Subject: Arkansas Nuclear One - Unit 2
Docket No. 50-368
License No. NPF-6
Response to First Request for Additional Information from the NRC Reactor
Systems Branch Regarding the ANO-2 Power Uprate License Application

**Request for Additional Information
from Reactor Systems Branch Personnel Regarding the
Arkansas Nuclear One, Unit 2 (ANO-2) Power Uprate License Application**

SAR FIGURE NO. 4.I-1

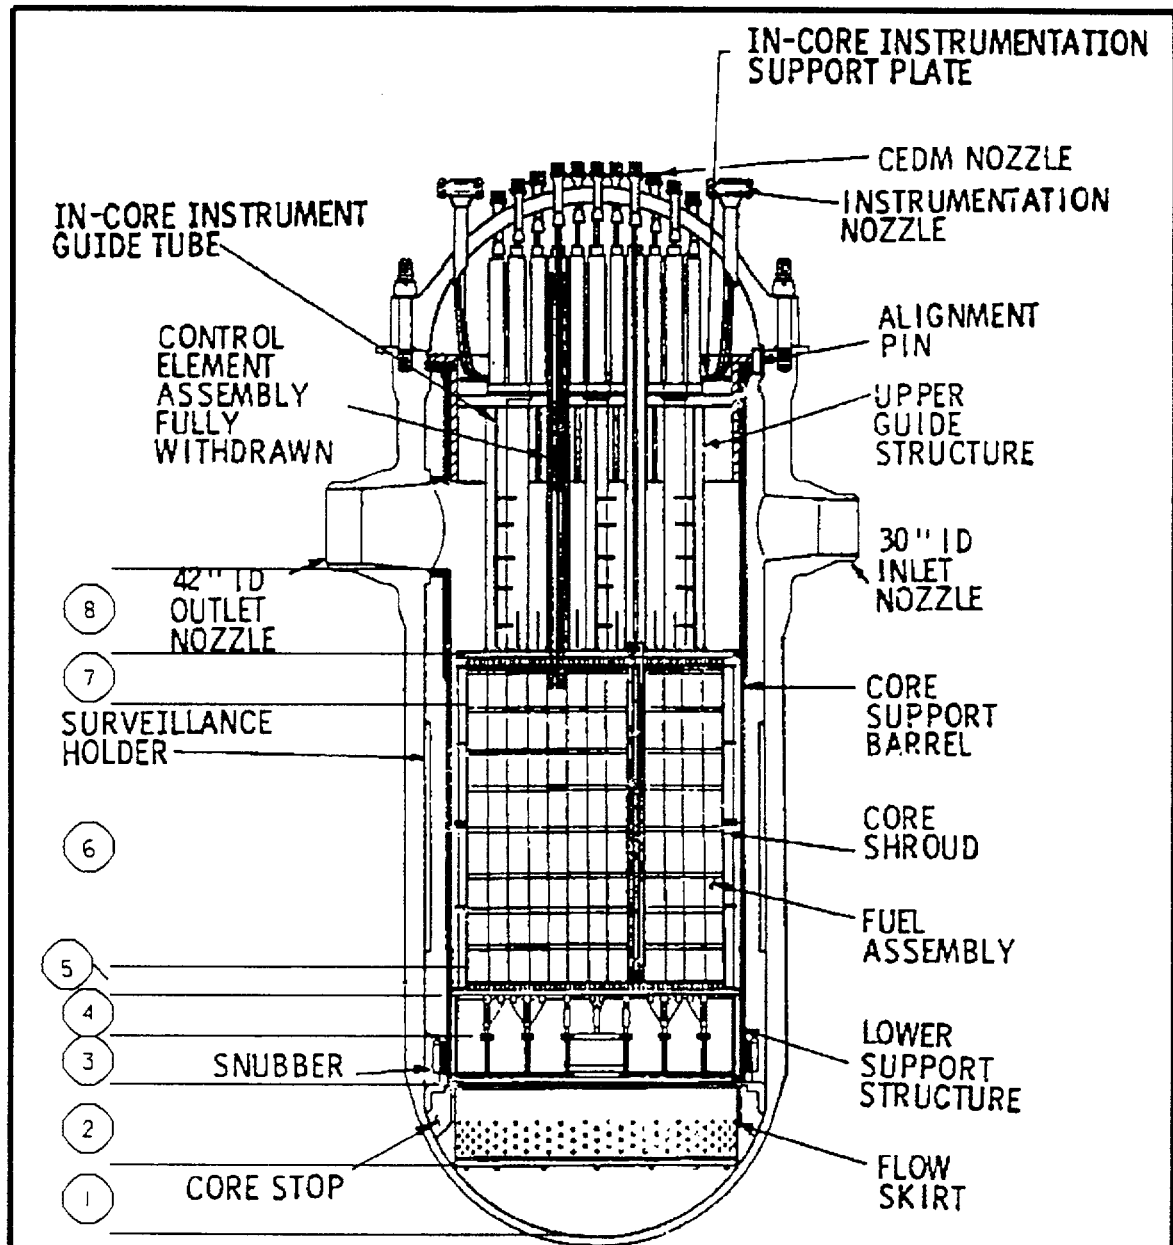
During the September 27, 2001, conference call, the staff requested the value of the mixing volume used in the ANO-2 power uprate boric acid precipitation analysis, as well as various ANO-2 reactor vessel water volumes. A value of 10,532 gallons (1408 ft³) was calculated for the ANO-2 mixing volume. As a discretionary conservatism (i.e., a conservatism not required by the methodology), the input value used in the BORON code was reduced to 10,000 gallons (approximately a 5% reduction). Table 1 lists water volumes for the lower plenum, core, and outlet plenum regions of the ANO-2 reactor vessel. From the information presented in Table 1 on the following page, the total water volume that is inside the core support barrel (excluding the water between the core support barrel and the core shroud) and between the top of the core support structure and the bottom of the core barrel outlet nozzles (i.e., Regions 5 through 8), is 968.1 ft³.

1. See ANO-2 SAR Figure 4.1-1 (next page) that has been annotated with circles drawn around numbers 1-8 to depict the top and bottom elevations of Regions 1 through 8.

FIGURE (1)

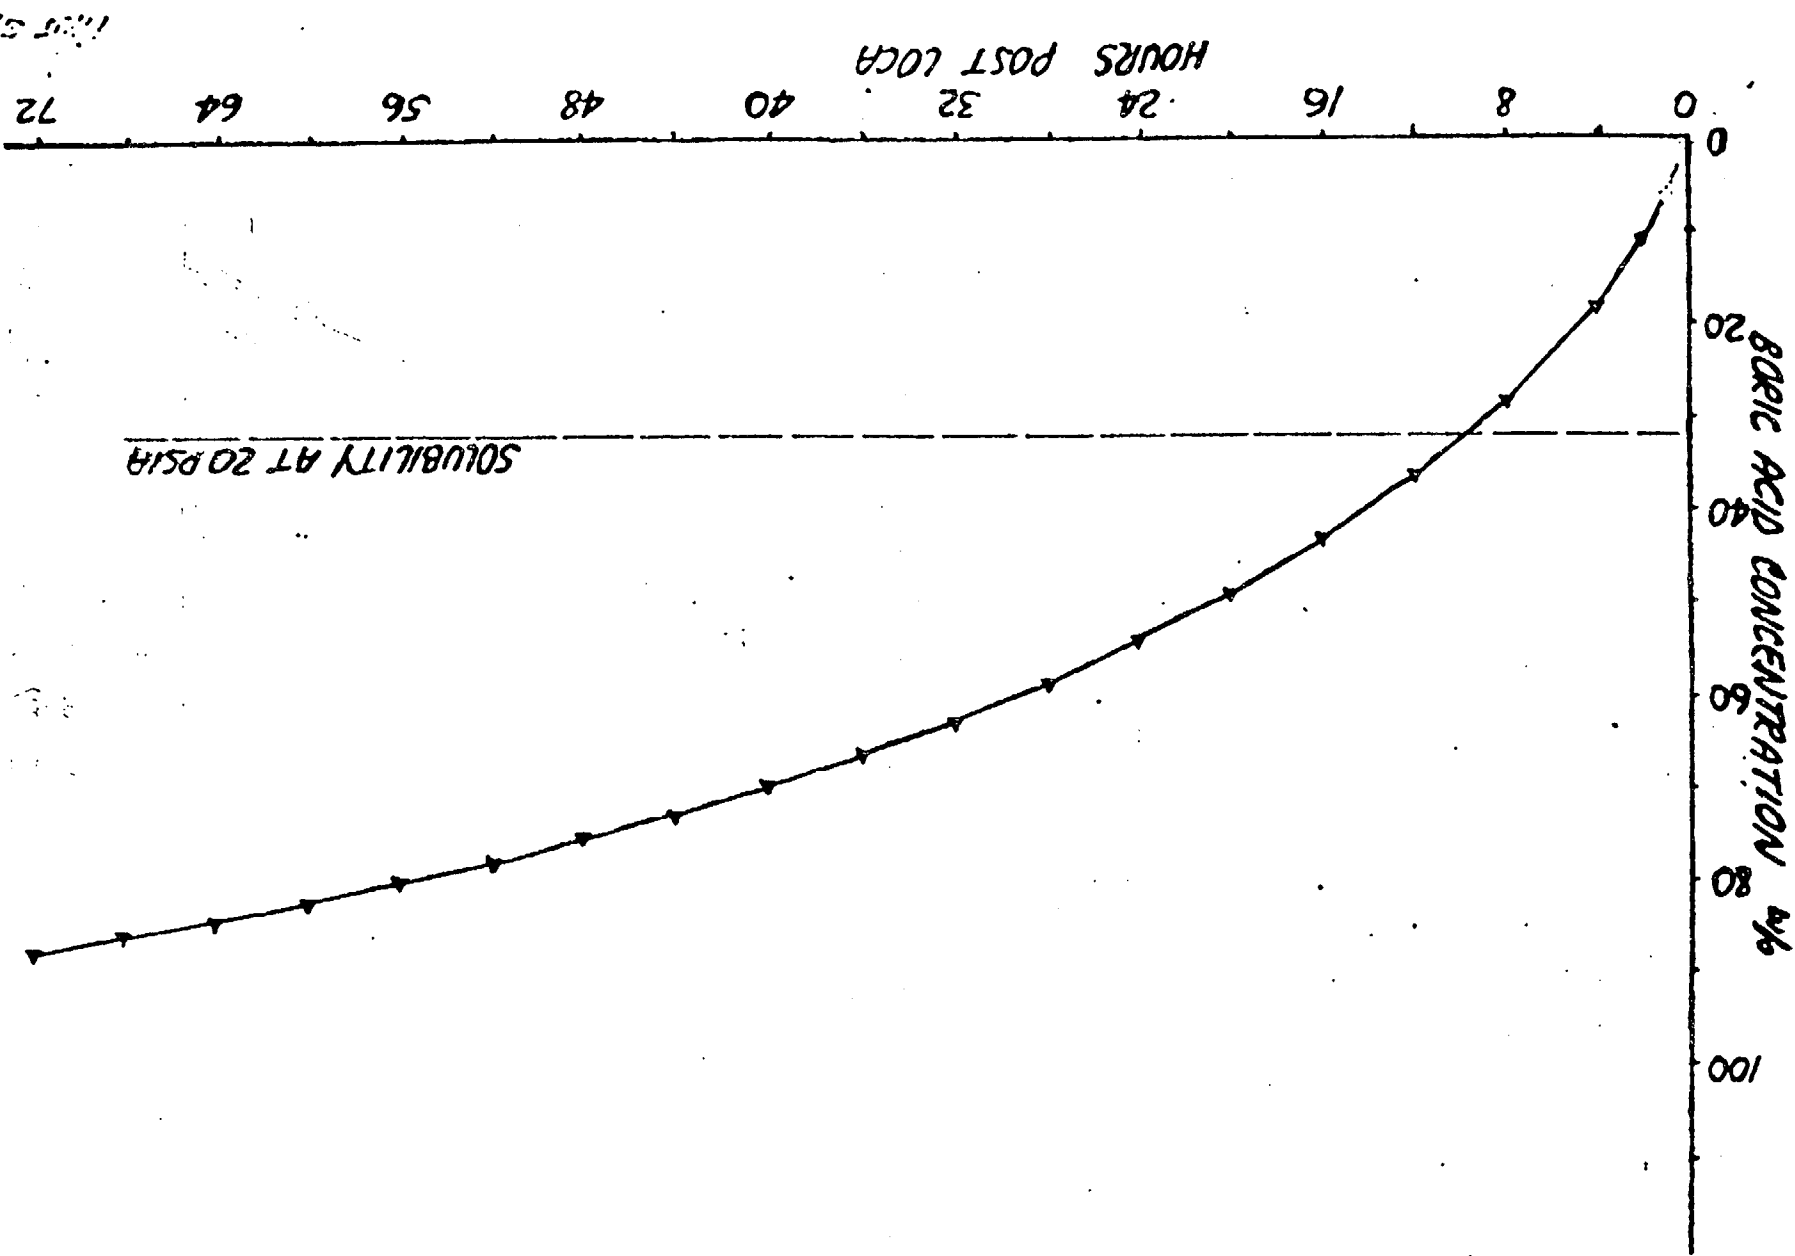
The concentration of boric acid in the reactor vessel has been modeled as a function of time by establishing a boric acid mass balance for the reactor vessel. Results of this model are presented in Figure (1).

Precipitation of solids is assumed to occur in the reactor vessel when the concentration matches the solubility at the solution temperature. On Figure (1), developed for a conservative system pressure of 20 psia, the boric acid solubility is approximately 32 wt%. Due to the complexities involved in predicting the nature, location and extent of precipitation, no precipitation will be tolerated and a core flushing flow will be initiated prior to reaching this solubility limit.

FIGURE (3)

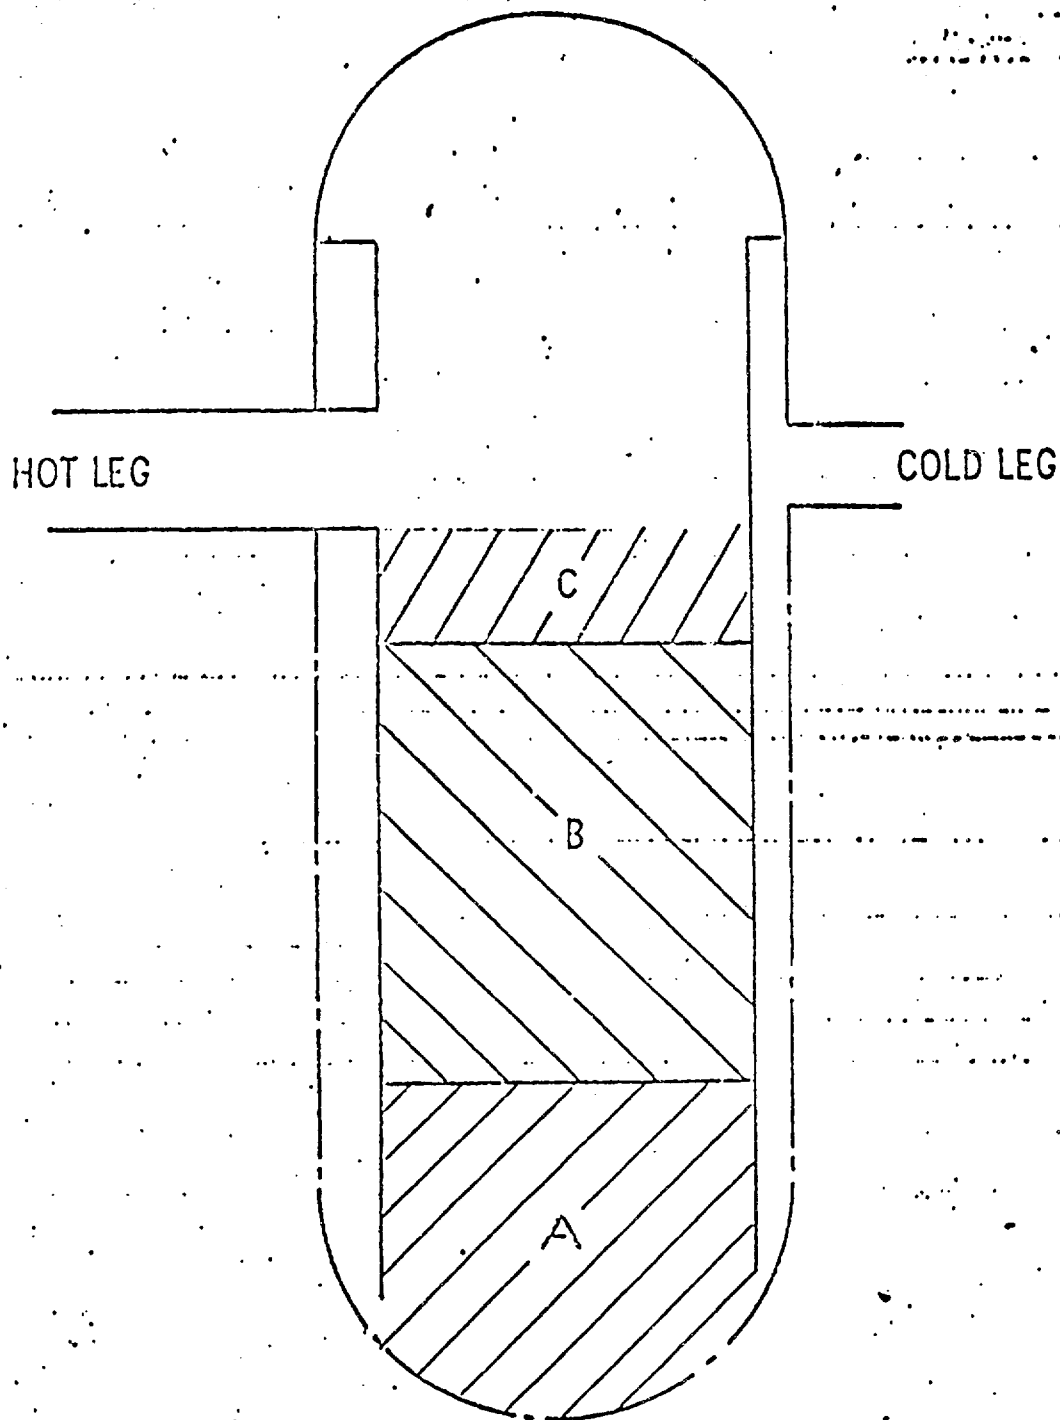
A special effort was extended to model the post-LOCA reactor vessel liquid inventory as a function of time. (This is the solvent for the boric acid solution.) The reactor vessel has been divided into three regions, as shown in Figure 3. Region "A" is defined as the free volume from the lower plenum to the bottom of the core (excluding the annulus); Region "B" is the free volume of the core; and region "C" is the region from the top of the core to the bottom of the hot leg. Region "A" is assumed to be entirely liquid. Regions "B" and "C" are two-phase regions with liquid masses calculated as a function of time based upon the two-phase model of Reference 9. A mean void fraction is determined for Region "B"; the surface void fraction at the interface of Regions "B" and "C" is conservatively assumed to be the void fraction throughout Region "C".

- c. The mass of liquid in the reactor vessel is calculated as a function of time by adding the liquid masses of Regions "A", "B", and "C" of Figure 3. It is further assumed that there is complete mixing of the liquid inventory in Regions "A", "B", and "C" of Figure 3. This has been confirmed by laboratory testing.
